Service Information

Category S	Repair Guidance	Ref. No. R098/13	Page 1 of 4
Coverage <input type="checkbox"/> Distributor only <input checked="" type="checkbox"/> Please inform your dealers		Date Issued November 22, 2013	
Please convey this information to your <input type="checkbox"/> Director <input checked="" type="checkbox"/> General Manager <input checked="" type="checkbox"/> Warranty Dept. <input checked="" type="checkbox"/> Parts Dept. <input checked="" type="checkbox"/> Training Dept. <input type="checkbox"/> Field Rep.		Date Revised	
Applicable Model CX-5 (KE)		Applicable Countries or Specifications Europe

Subject: Bonnet vibrates when driving at more than 110Km/h

(Modification of the cowl grill seal)

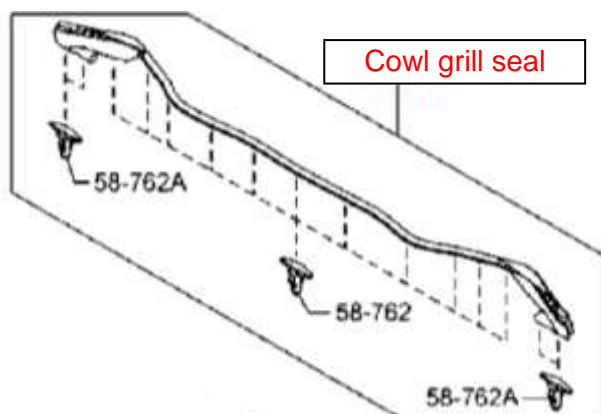
In addition to the recent improvement to the above Cause No. 1 (increase of applied adhesive amount), as a measure for the Cause No. 2 the preload force of the cowl grill seal has been increased to reduce bonnet vibration.

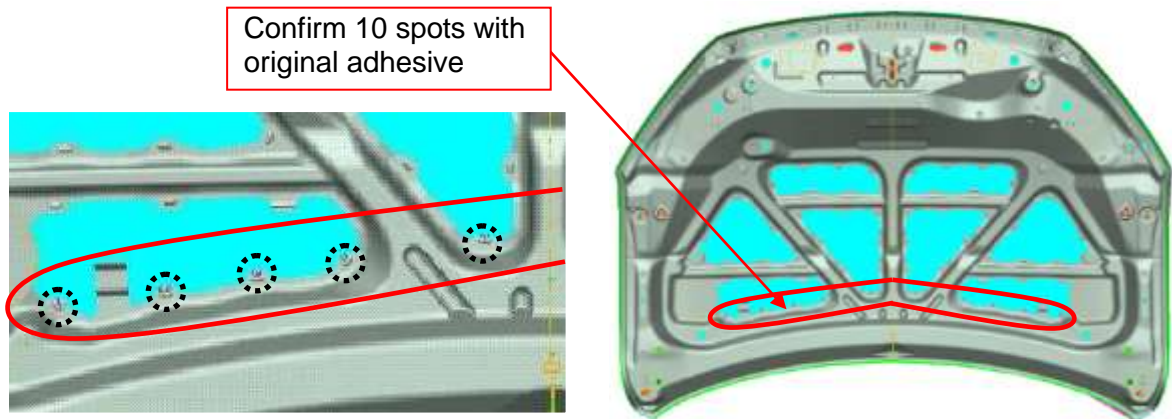
4. Fill additional adhesive into the gap between the outer panel and the inner frame at the back of the bonnet according to the following procedure.

- (1) Confirm the 10 spots with the adhesive shown in the figure. Additional adhesive should be applied between these 10 original adhesive spots.

NOTE: For other original adhesive spots, it is not necessary to apply additional adhesive even if the adhesive is already separated because it does not influence the bonnet vibration.

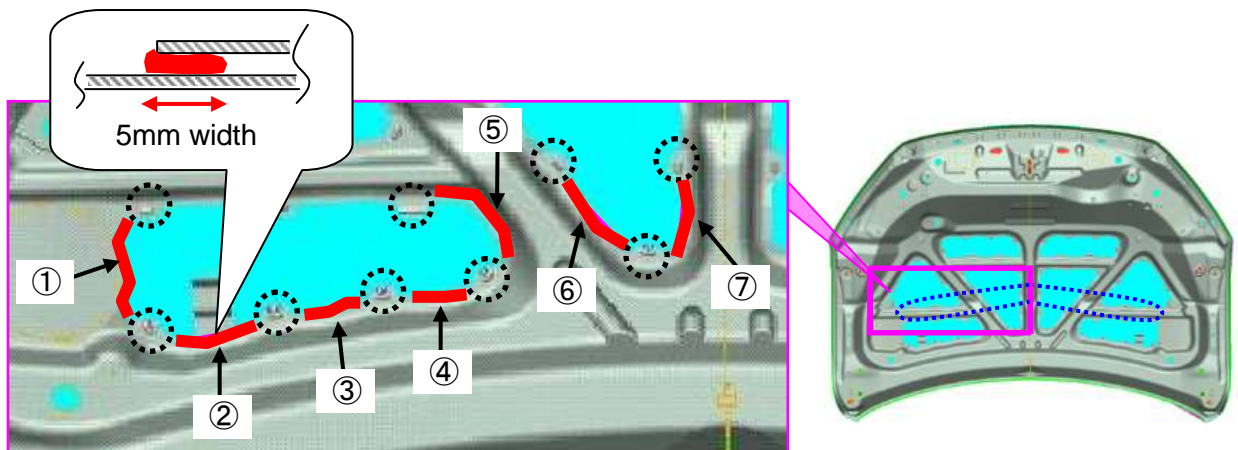
- (2) Apply 5mm width additional adhesive spots by filling in the gaps in between the outer panel and the inner frame between the factory applied adhesive spots. (Apply adhesive at ①~⑦ spots in the figure).

NOTE: The illustration shows the right half of the bonnet. For the left half, apply adhesive at the same 7 spots in the same manner as on the right half. Adhesive must be applied at total 14 spots.

NOTE: It is not necessary to apply additional adhesive over the factory applied adhesive spots even when they are already separated.

NOTE: Any surplus adhesive dripping off should be removed or smoothed with a spatula.
